Project #18-002
Juniper Systems West Addition
Located at 1132 West 1700 North

Project Name: Juniper Systems West Addition
Proponent / Owner: Mike Stettler, Stettler Construction / Juniper Systems Inc
Project Address: 1132 West 1700 North
Request: Design Review Permit
Current Zoning: Industrial Park (IP)
Type of Action: Quasi-Judicial
Date of Hearing: January 11, 2018
Submitted By: Amber Pollan, Senior Planner

RECOMMENDATION

4 West Elevation
Scale: 3/32" = 1'-0"

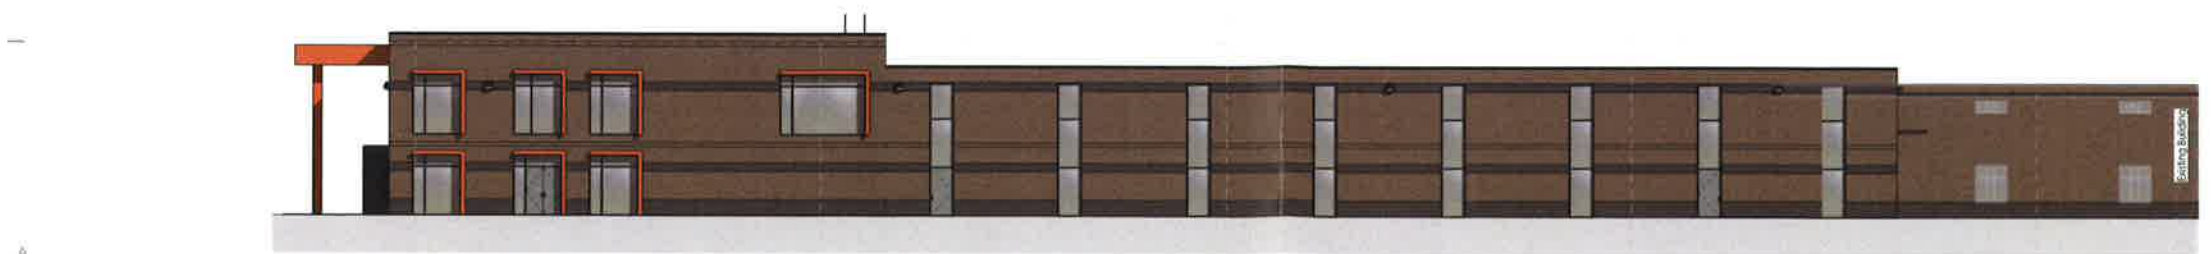
In the IP zone, blank wall lengths of 40' are prohibited. Breaks are provided by windows, changes in materials, and wall modulation. The LDC also requires a minimum of 30% transparency/fenestration on street-facing, ground-floor facades. The ground floor north elevation facing 1700 North is at approximately 70% transparency (windows). The west elevation facing 1200 West is at 22% transparency with windows and doors. The west elevation includes manufacturing space which limits the extent that windows can be used. This elevation

is also 165' from 1200 West and much of that space will be undeveloped wetlands. Due to the distance from 1200 West and needs of the manufacturing space, Staff recommends the use of landscaping along the drive area between the building and 1200 West to soften the building façade.

4. Landscaping elements to be added along the drive on the west side of the building to soften the elevation and provide additional interest.
5. A Boundary Line Adjustment is required to be submitted and approved by the Public Works Department to combine the lots for development.

Sheet Title
Utility Plan

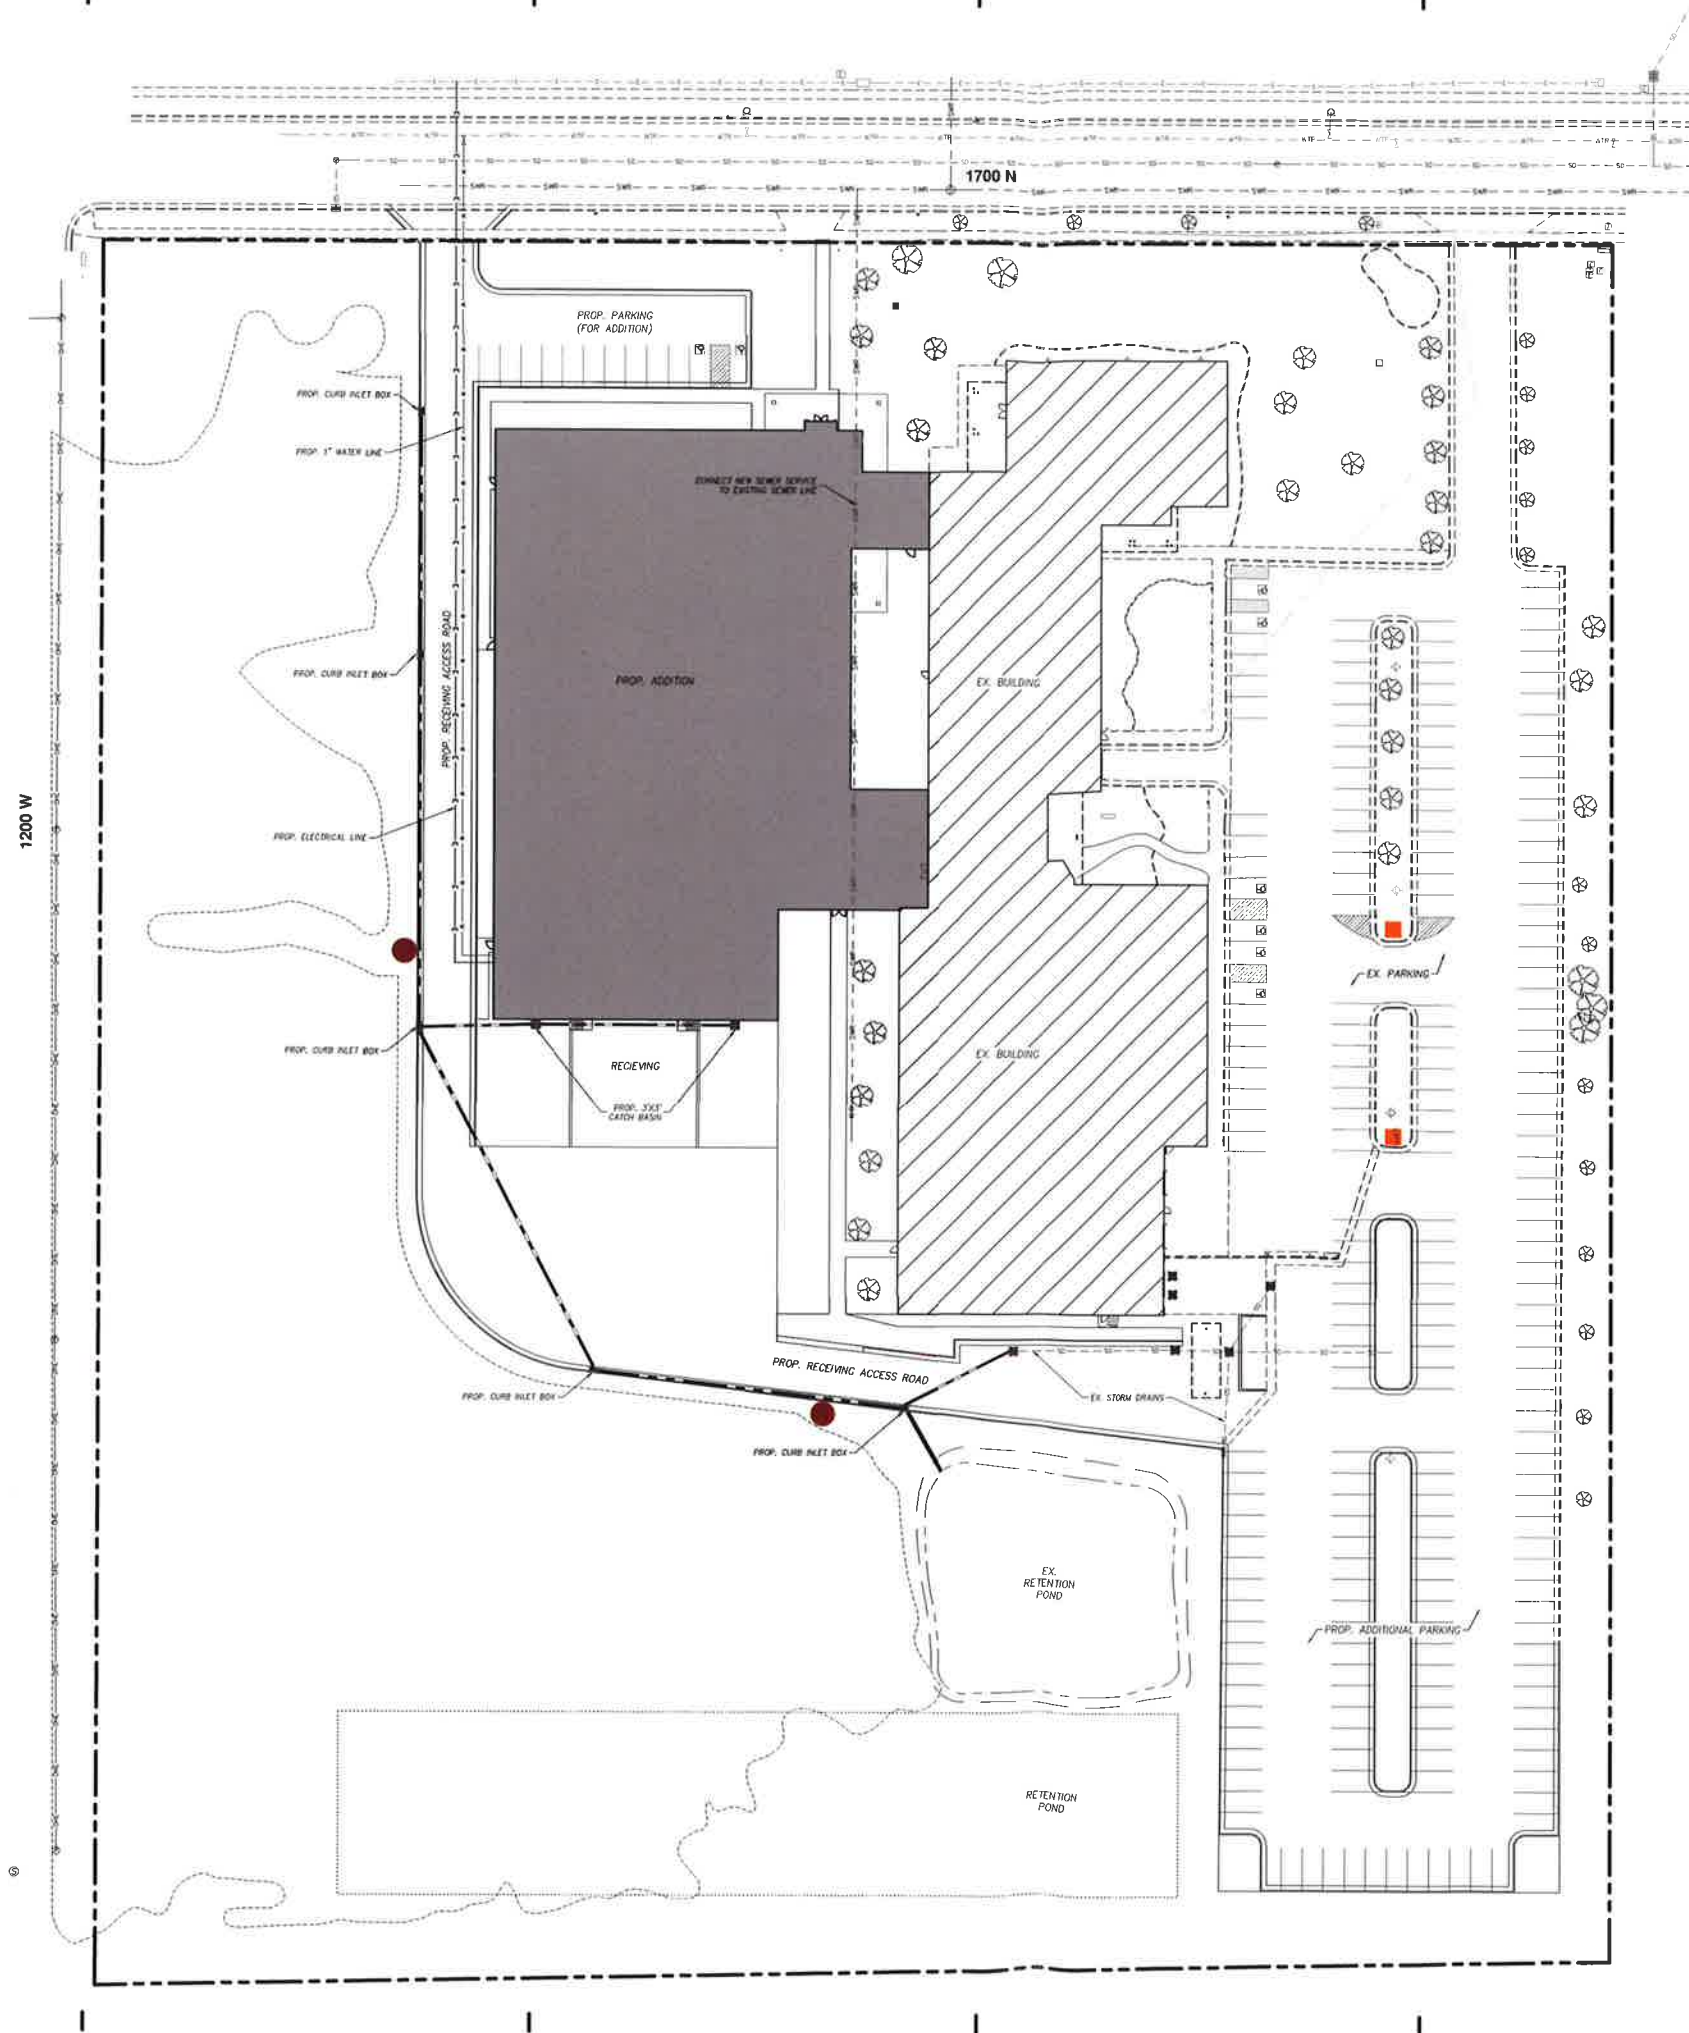
- i. Provide water shares or in lieu of fee for increased water demand
 - ii. The 1" water line shown shall be installed as a 1" line with a meter, setter and barrel per City standards. Meter, setter and barrel shall be located in park strip.

- iii. All existing sewer service lines from existing buildings which will be under new building shall be replaced/upgrade with pipe and fittings as required by IPC.

- iv. Provide storm water design per current Logan City Design Standards. This shall include implementation of Low Impact Design and retention of the 90% storm event.

- v. Any storm water which discharges to wetland area or if wetland area is to be used as storage, shall meet all pretreatment requirements from the Corps before discharge occurs.
